FINE'S GALLERY APPROVAL FORM

Customer: NES, LLC (Mr. Emad Hanna)

Model # MF-CUS

Material : Black hcbg01Granite

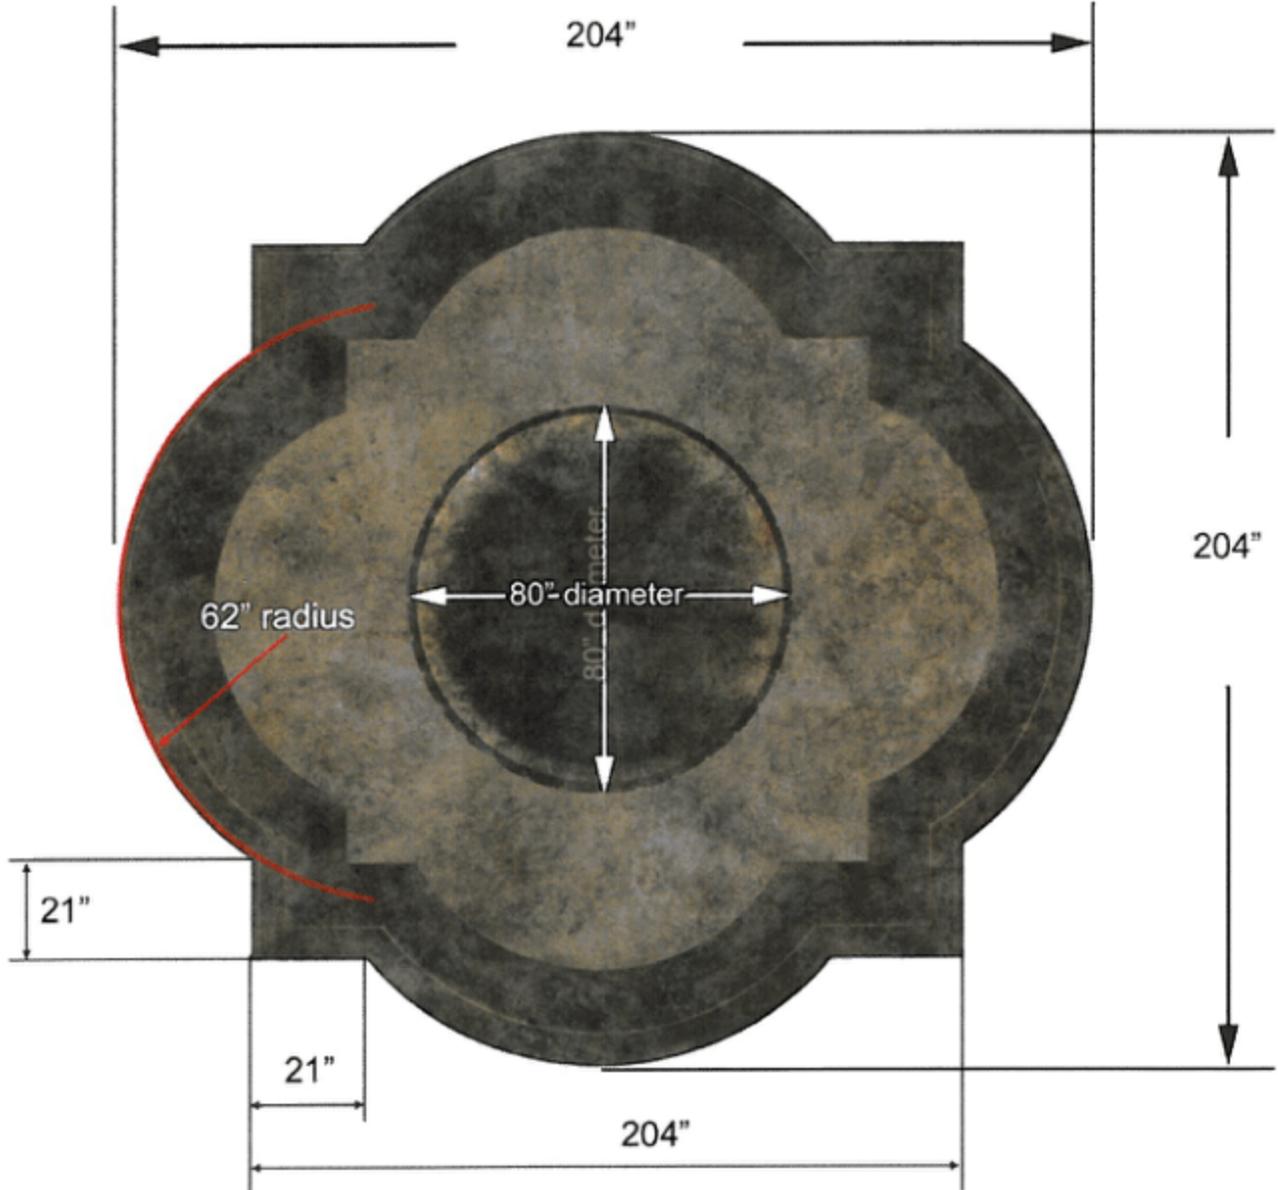
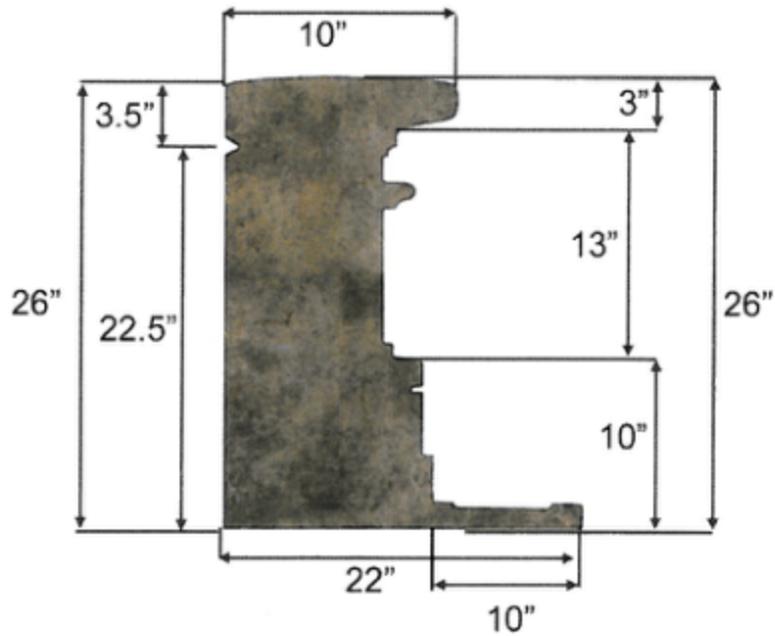
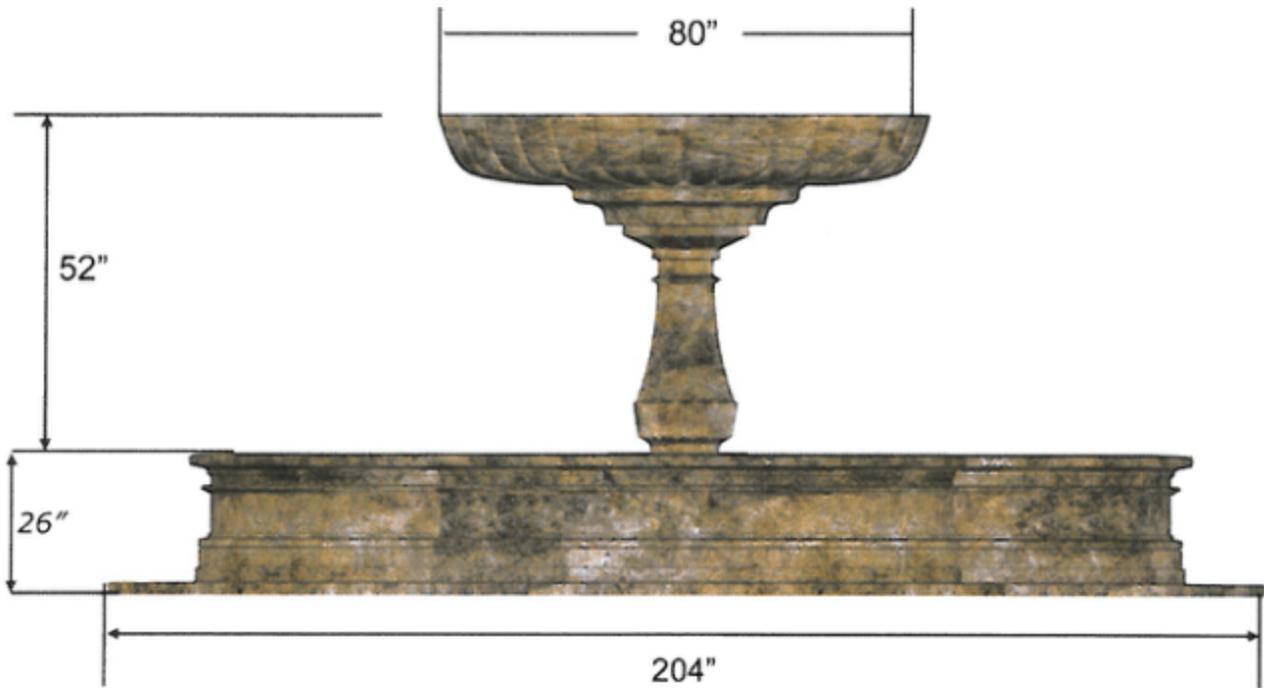
THE FOUNTAIN INDICATED ON
THE SHOP DRAWING IS TOO SMALL
THEY INDICATE THE OVERALL WIDTH
TO BE 138" (11'-6") WHICH IS ONLY
THE CENTRAL DIMENSION - THE
OVERALL WIDTH SHOULD BE 17'-0"
(204"). THE DIAMETER OF
THE BASIN ATOP PEDESTAL IS ALSO
TOO SMALL. SKETCH INDICATES
APPROX 108", SHOP DRAW ONLY 60"
SEE ATTACHED SKETCH.

PLAN OF FOUNTAIN

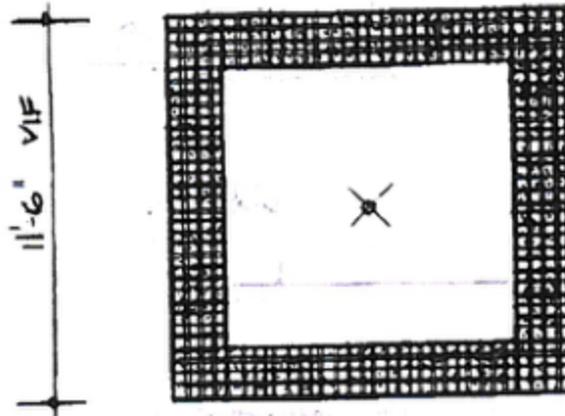
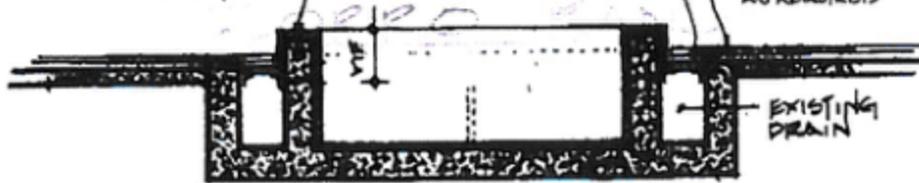
REMOVE APPROXIMATELY
6" TO 8" OF CONCRETE
ALL AROUND FOUNTAIN
BASIN W/CL TILE

REMOVE COVER
GRATING & DRAIN

REMOVE PAVING
AS REQUIRED
